To: T10 Technical Committee
 From: Rob Elliott, HP (elliott@hp.com)
 Date: 26 April 2007
 Subject: 07-089r1 SAS-2 Redundant primitive sequence error handling

Suggested changes to SAS-2

Figure 148 — Triple primitive sequences

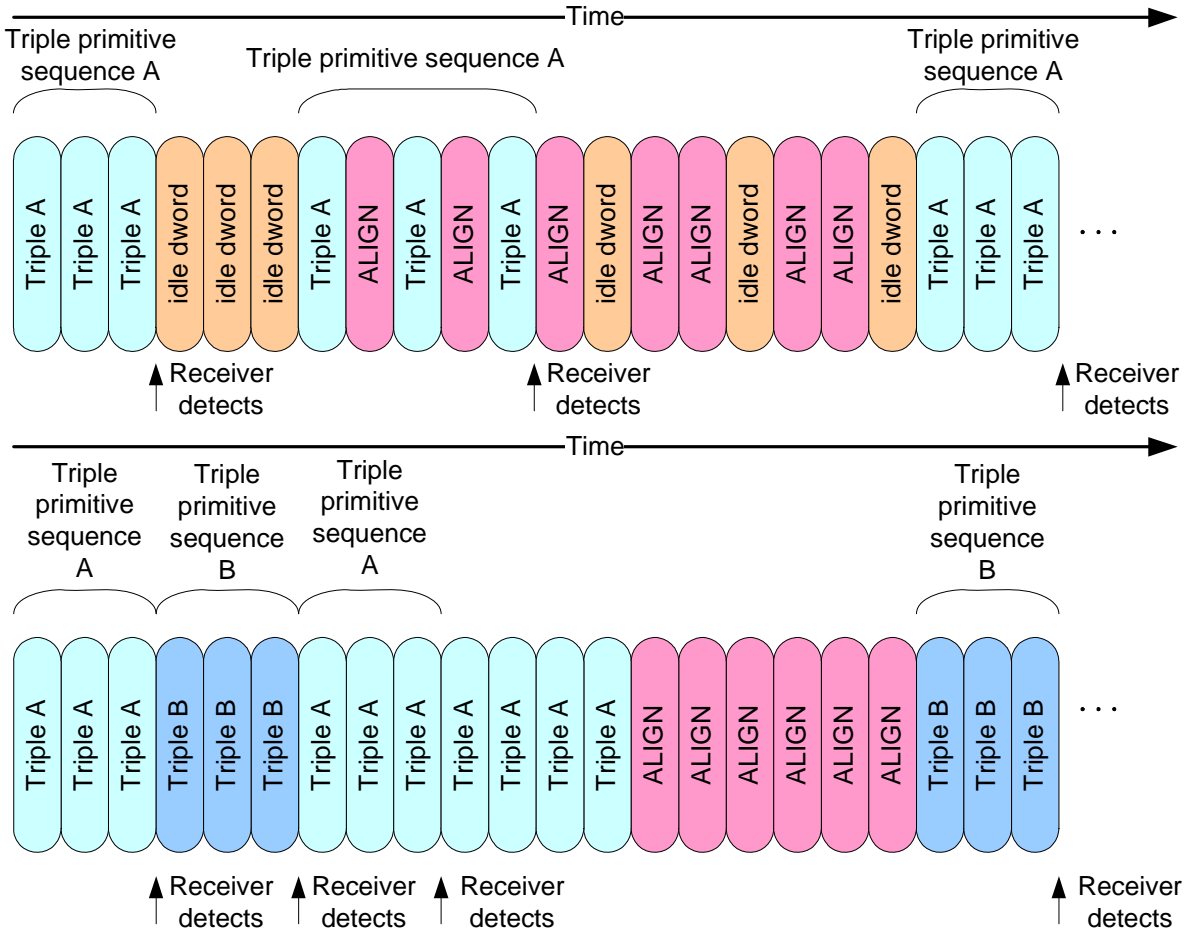
Receivers shall detect a triple primitive sequence after the identical primitive is received in three consecutive dwords. After ~~receiving~~ detecting a triple primitive sequence, a receiver shall not detect a second instance of the same triple primitive sequence until it has received three consecutive dwords that are not any of the following:

- a) the original primitive; or
- b) a deletable primitive.

[A triple primitive sequence that begins within three dwords after a receiver detects a redundant primitive may or may not be detected \(see 7.2.4.7\).](#)

Figure 149 — Redundant and triple primitive sequences [modified]

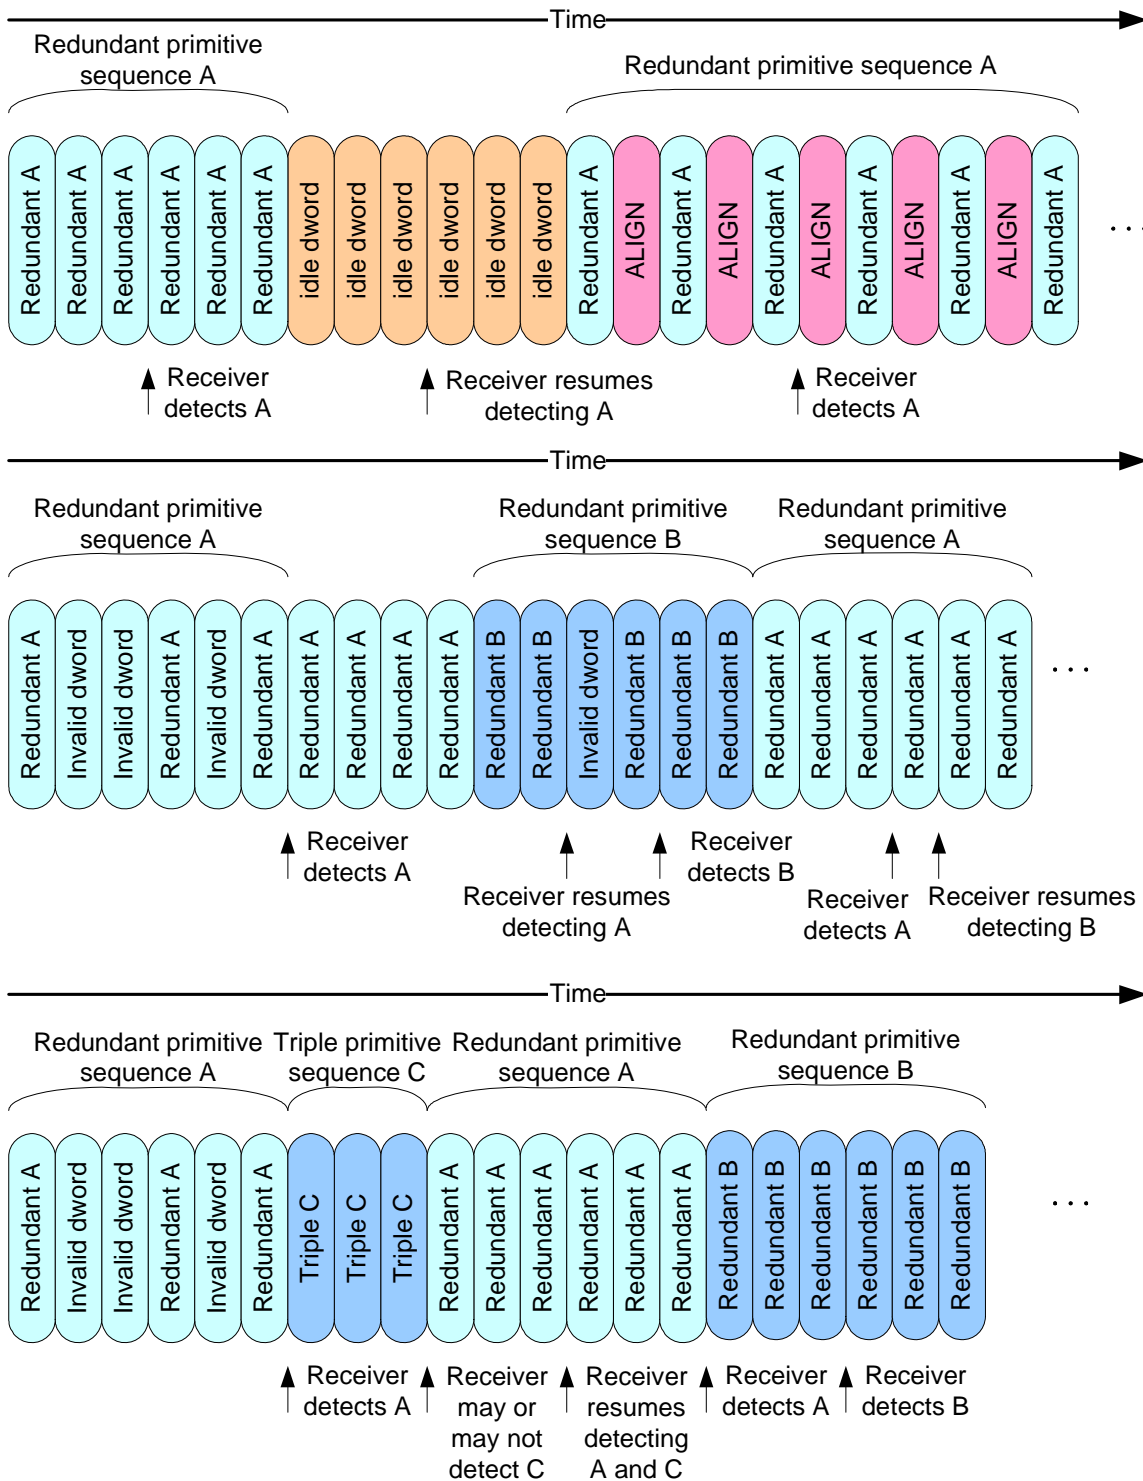
A receiver shall detect a redundant primitive sequence after the identical primitive is received in any three of six consecutive dwords. After ~~receiving~~[detecting](#) a redundant primitive sequence, a receiver shall not detect a second instance of the same redundant primitive sequence until it has received six consecutive dwords that are not any of the following:

Editor’s Note 1: It would be a change from SAS-2 to change that “six” to “three”, but that might make sense so the transmitter can send redundant A - triple - redundant B without having to add 3 fill dwords. If it does not, the receiver only starts detecting B midway, leaving it sensitive to bit errors.

Editor's Note 2: more invalid dwords added to the picture. 3rd row added showing interaction

[between redundant and triple.](#)

After detecting a redundant primitive sequence, the receiver may or may not detect another redundant primitive sequence or a triple primitive sequence that occurs within the next three consecutive dwords.
